Freedom space for rivers: a sustainable management approach to enhance river resilience --Manuscript Draft--

Manuscript Number:	EMVM-D-13-00374R1
Full Title:	Freedom space for rivers: a sustainable management approach to enhance river resilience
Article Type:	Research
Abstract:	River systems are increasingly under stress and pressure from agriculture and urbanization in riparian zones, resulting in frequent engineering interventions such as bank stabilization or flood protection. This study provides guidelines for a more sustainable approach to river management based on hydrogeomorphology (HGM) concepts applied to three contrasted rivers in Quebec (Canada). Mobility and flooding spaces are determined for the three rivers and three levels of "freedom space" are subsequently defined based on the combination of the two spaces. The first level of freedom space includes very frequently flooded and highly mobile zones over the next 50 years, as well as riparian wetlands. It provides the minimum space for both fluvial and ecological functionality of the river system and corresponds to a highly variable width, approximately 1.7 times the channel width on average, for the three studied sit

Figure 1.a) Location of the three study sites in Québec, Canada; b) Matane River study reach; c) de la Roche River study reach; d) Yamaska Sud-Est River and North-Branch tributary study reach.

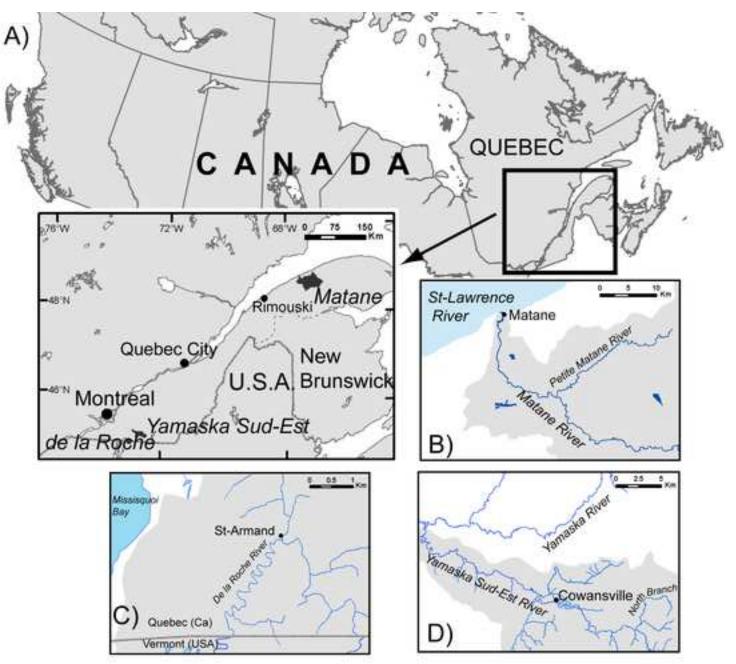
Figure 1: Images are blurry. Could be useful to have a larger scale Canada map. In the situation map, add the extent of the other maps.

We have added a larger scale location map (of Canada), and improved the resolution of the other figures so Figure 1 is no longer blurry.

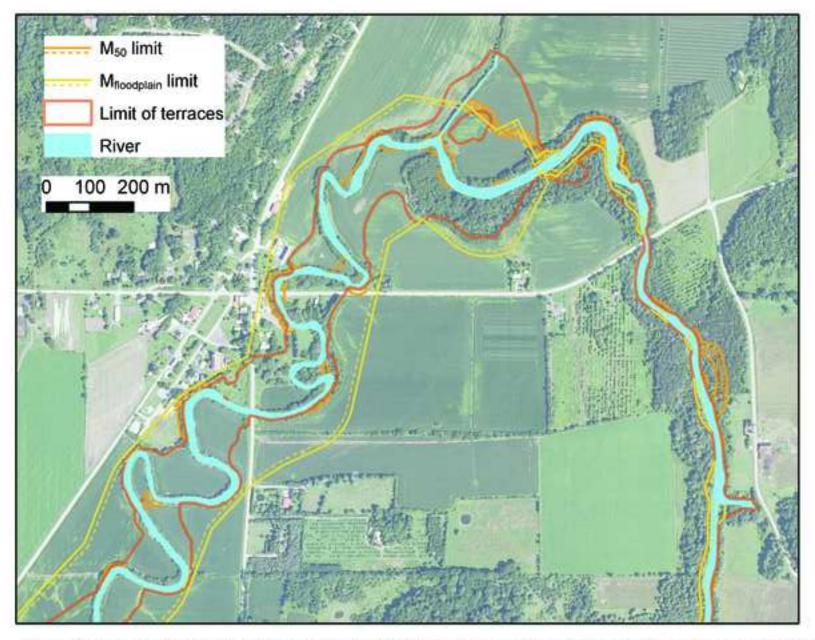
Figure 4: Could we also have the M1 on this map to compare?

We have added M1 (now M_{50}) limits on the map.

Figure 6: Examples of HGM cartography of the flooding space for a) the de la Roche River, b) the Yamaska Sud-Est River and c) the Matane River

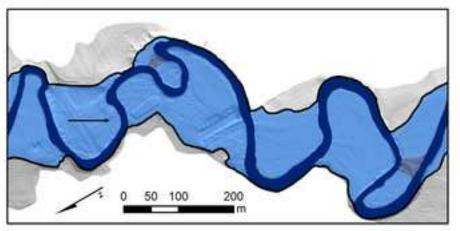
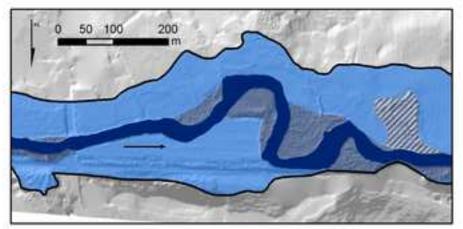
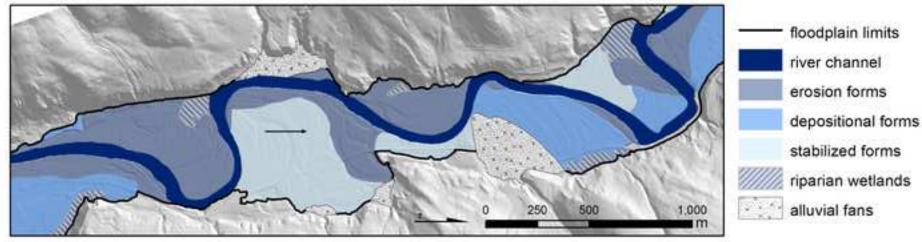
9. Figures 5 and 6 - A few changes. The projection information is unnecessary for this figure. There are also problems with the coordinates overlapping. I would remove the coordinates and replace with a scale bar in m or km. However, if the coordinates must be shown, please space them further apart or only put them at the edges of each box.

Figures 5 and 6 were modified to remove information on projection and replace the coordinates with a scale bar.

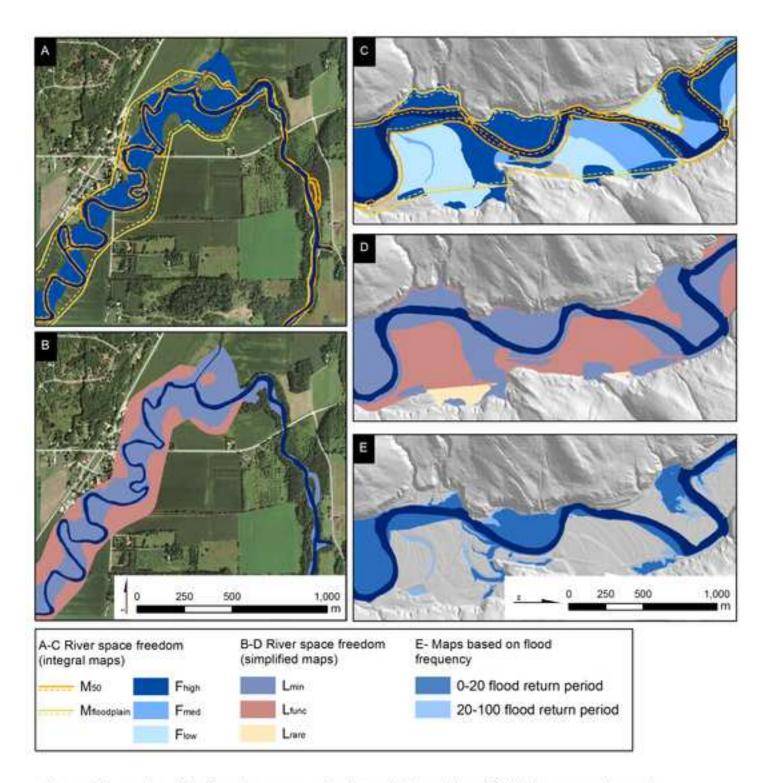
8. Figure 7 map legend is in French and impossible to see in print. Increase the size of fonts for both the main legend, and either get rid of the boxes with "Espace de liberte" (sorry no accents) or change to be readable.

We have modified Figure 7 (now Figure 8) so that the legend is translated in English and the font size is increased.

Figure 9: Examples of the freedom space in the Yamaska Sud-Est River a) in an area with a riparian wetland, b) in the municipality of Cowansville, located approximately 10 km downstream of the wetland.

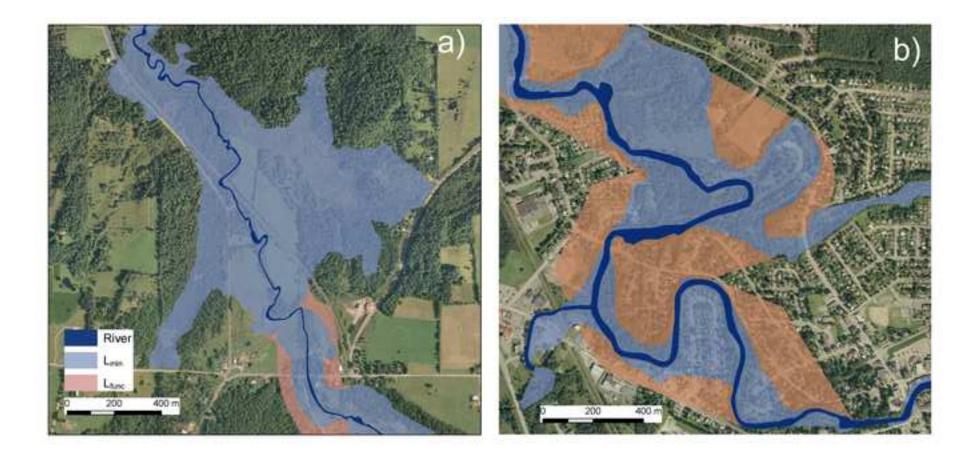
10. Figure 8 - increase the size of the font in the legend and scale bar. All fonts in figures should be near size 12.

The font size in the legend and the scale bar were increased in Figure 8 (now Figure 9).
